TENNESSEE VALLEY AUTHORITY

Several telephone conference calls and meetings have recently been held between TVA and NRC representatives to discuss TVA's proposed changes to technical specification 4.6.4.3 regarding surveillance requirements for demonstrating operability of hydrogen ignitors.

WATTS BAR NUCLEAR PLANT

TEMPERATURE vs CURRENT MEASUREMENTS OF HYDROGEN IGNITORS

S/N 810

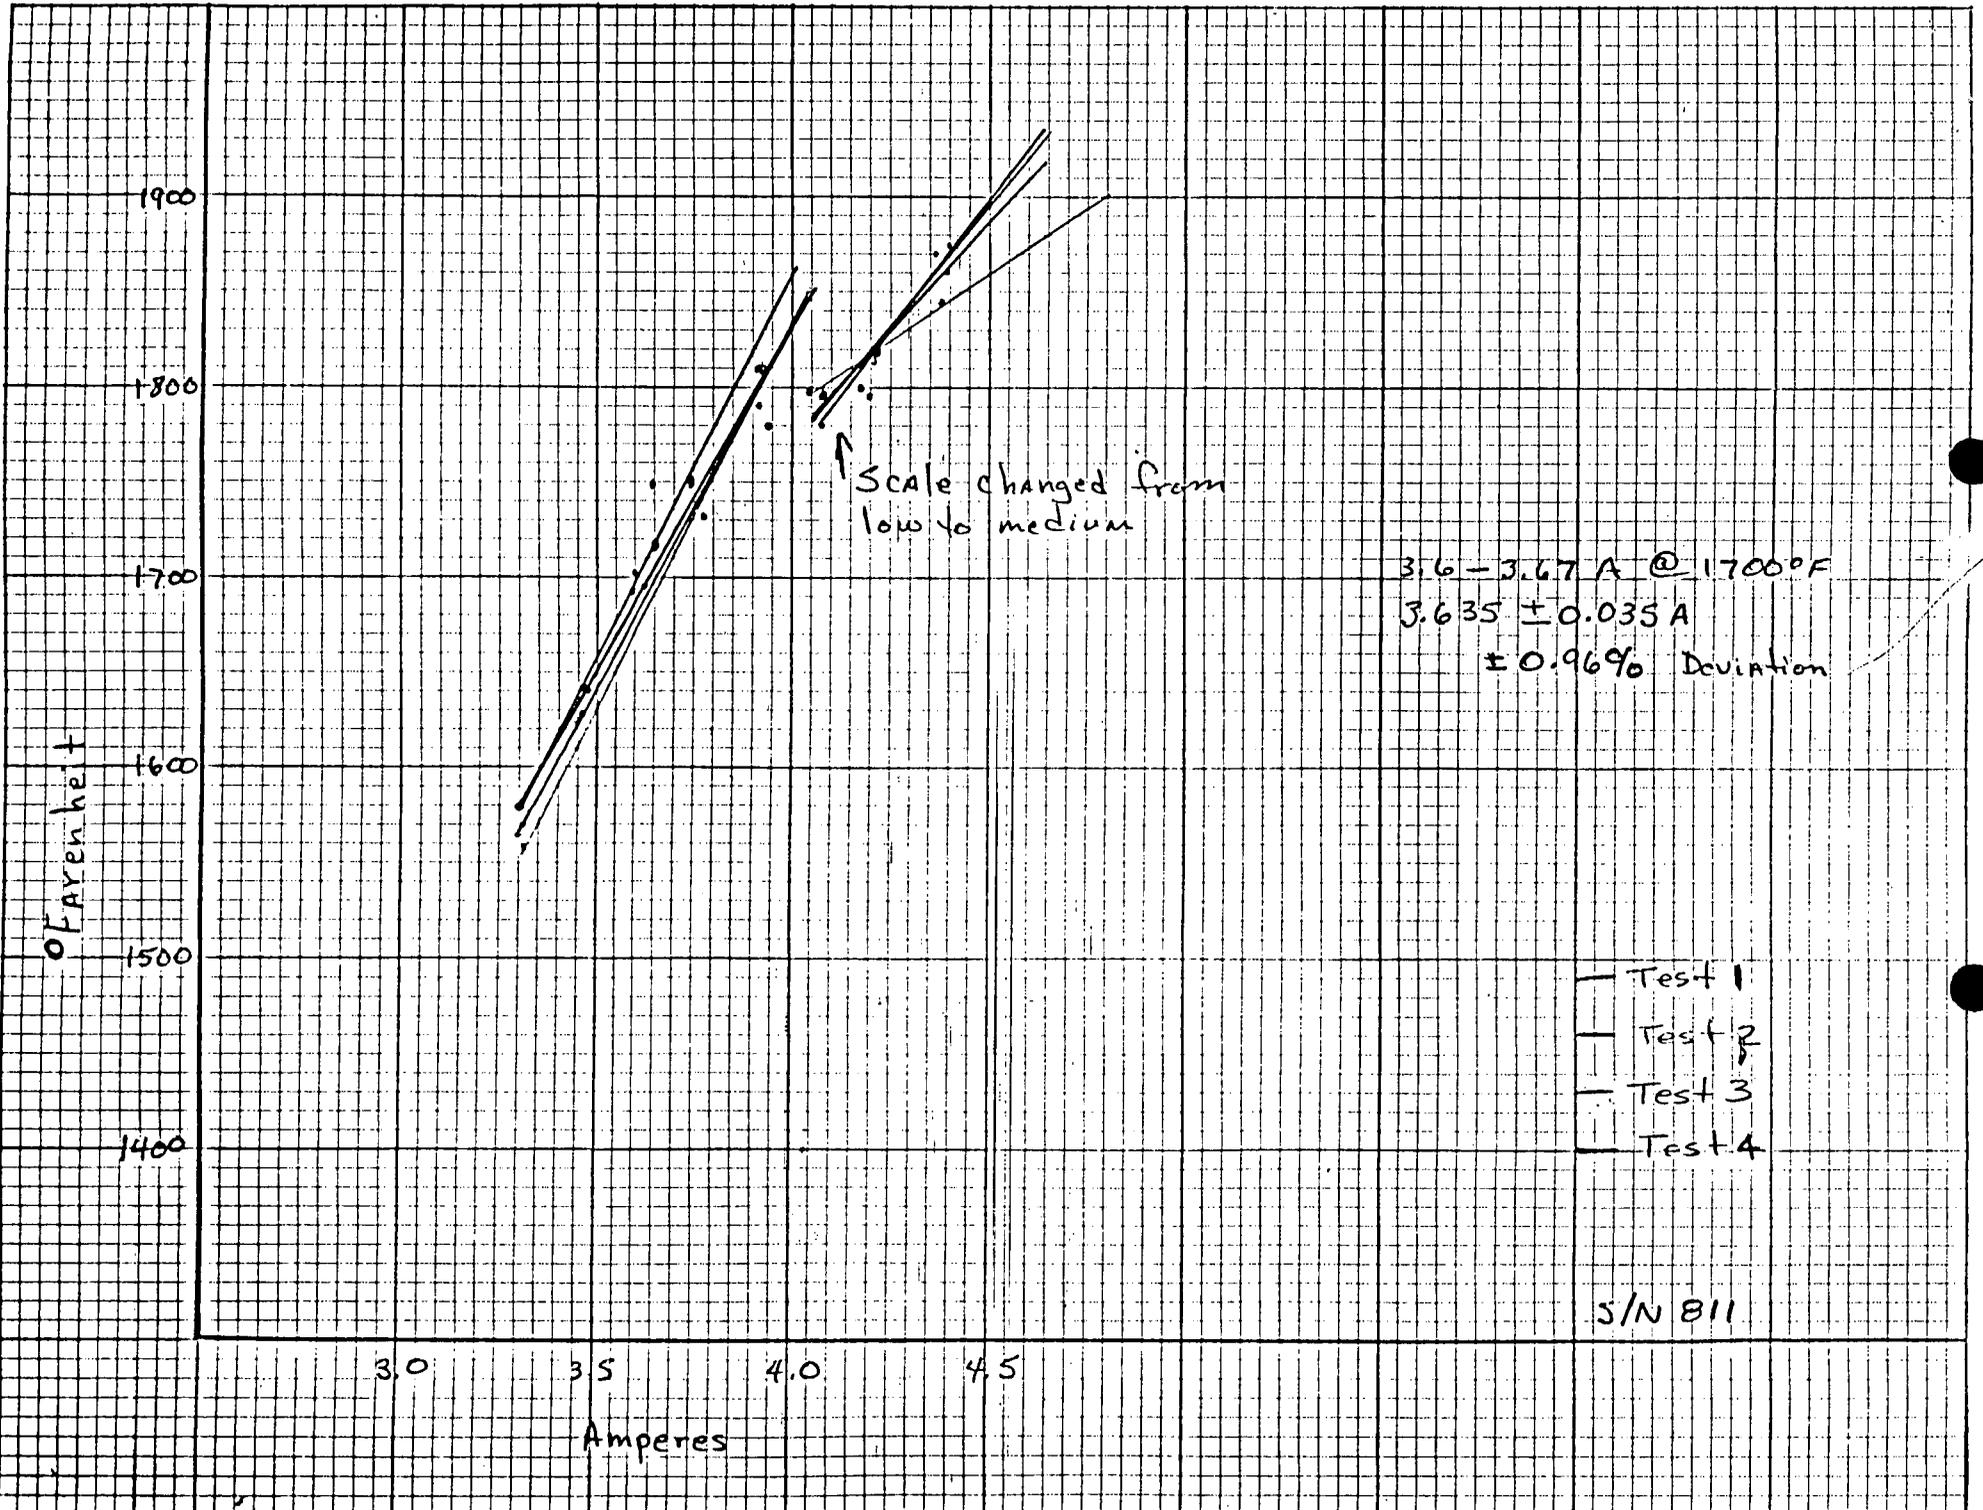
Scale changed from
low to medium

3.58 - 3.67 A @ 1700°F
3.625 ± 0.045 A
± 1.24% Deviation

S/N 817

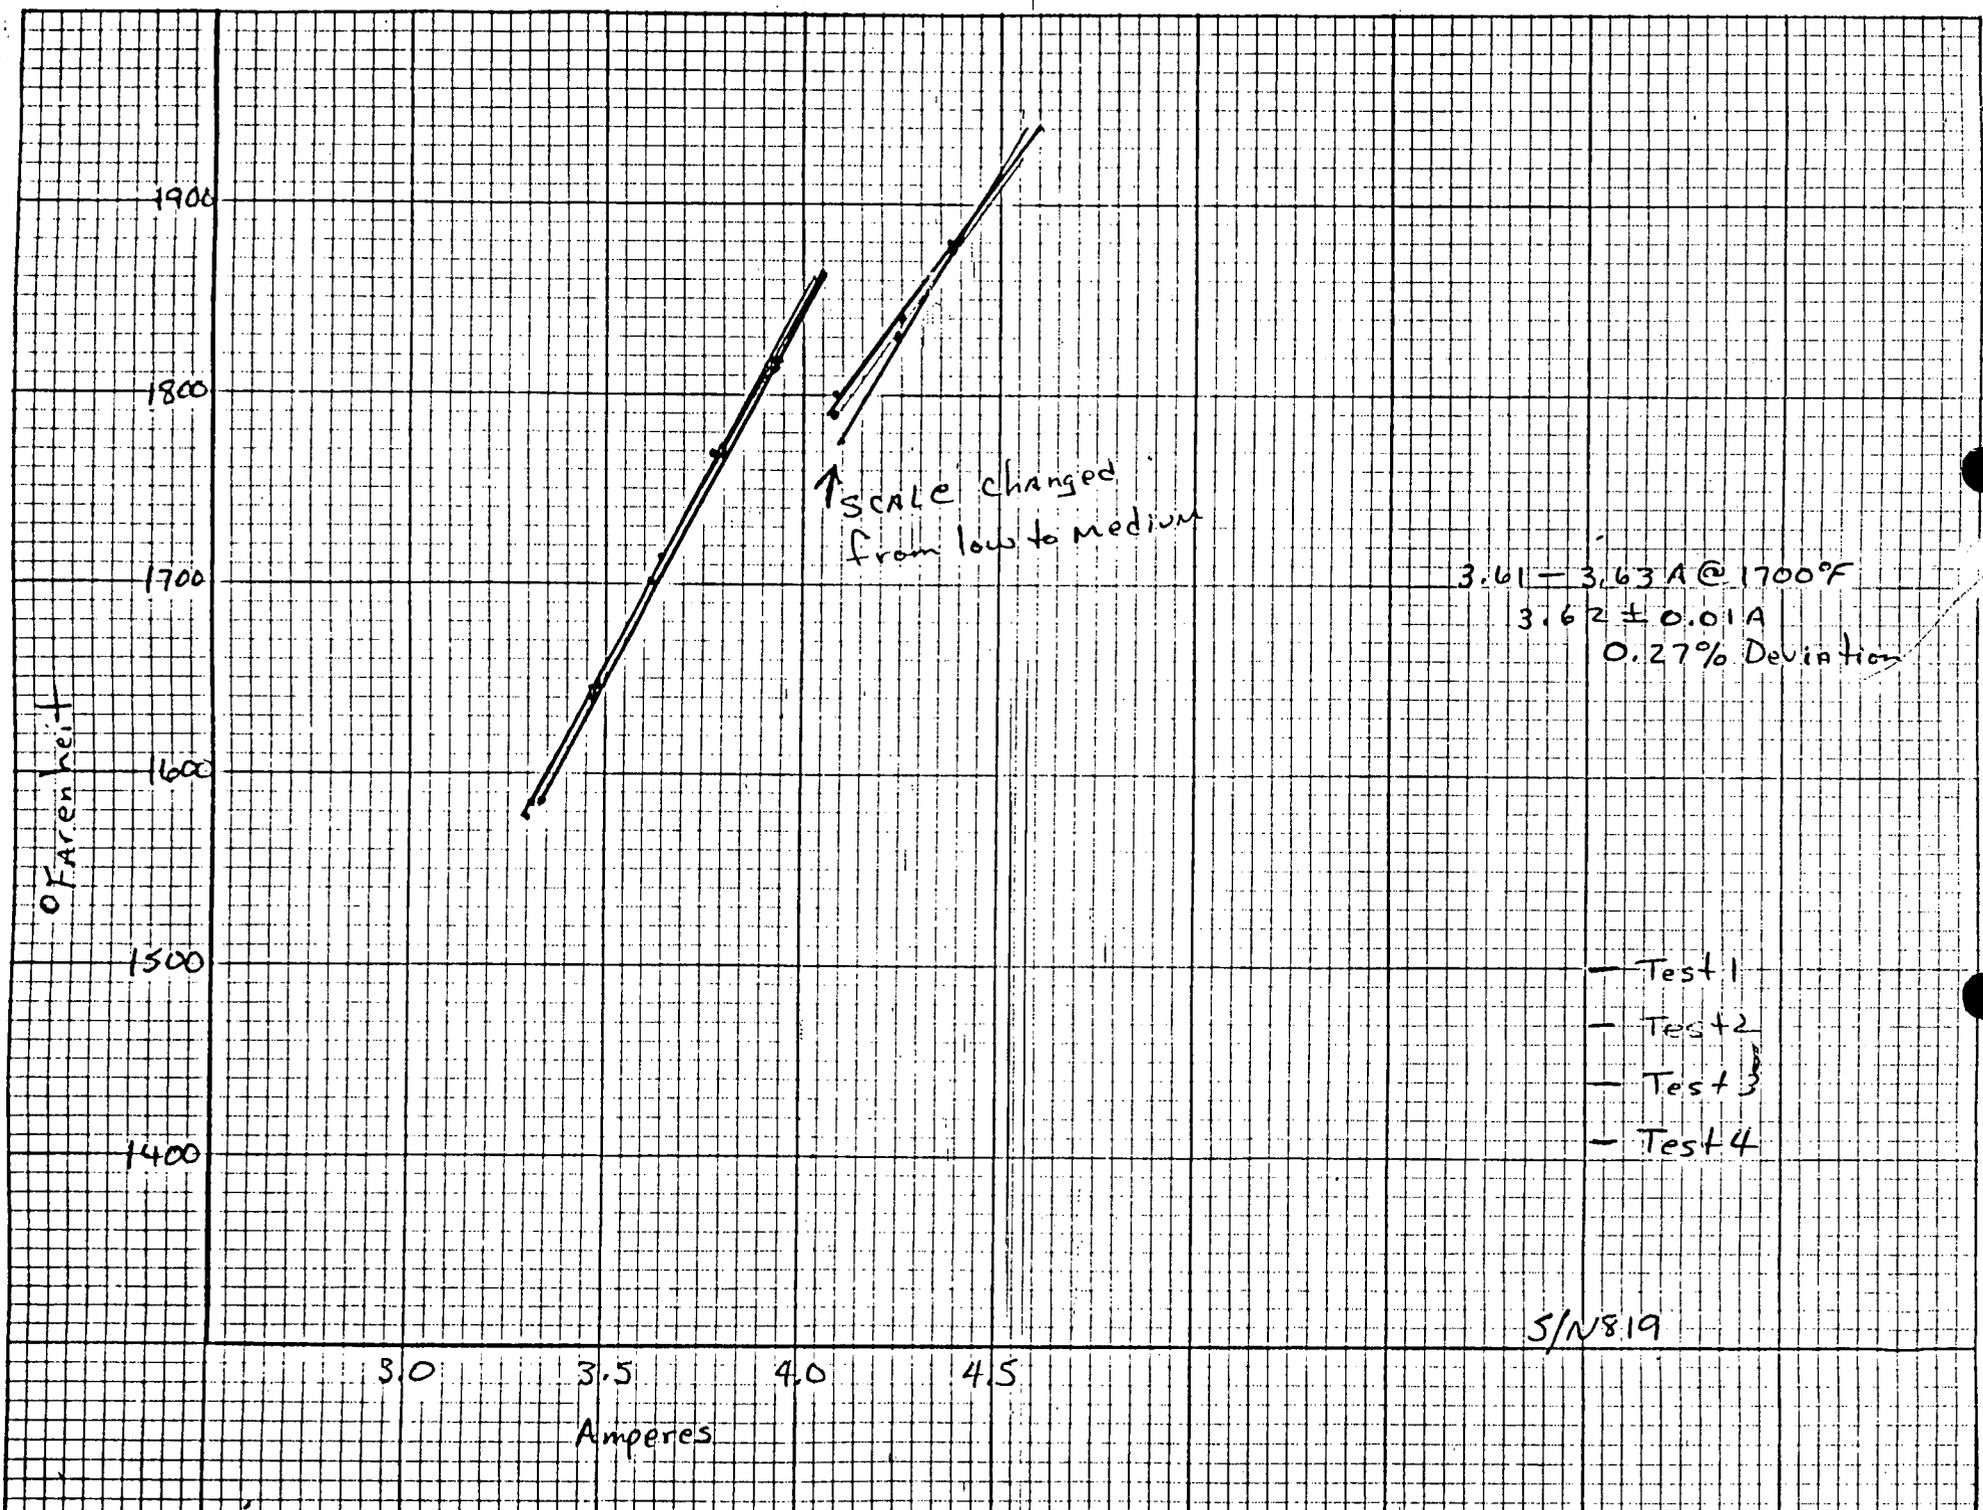
Scale changed from low to medium

3.6 - 3.64 A @ 1700°F
3.62 ± 0.02 A
± 0.55% Deviation
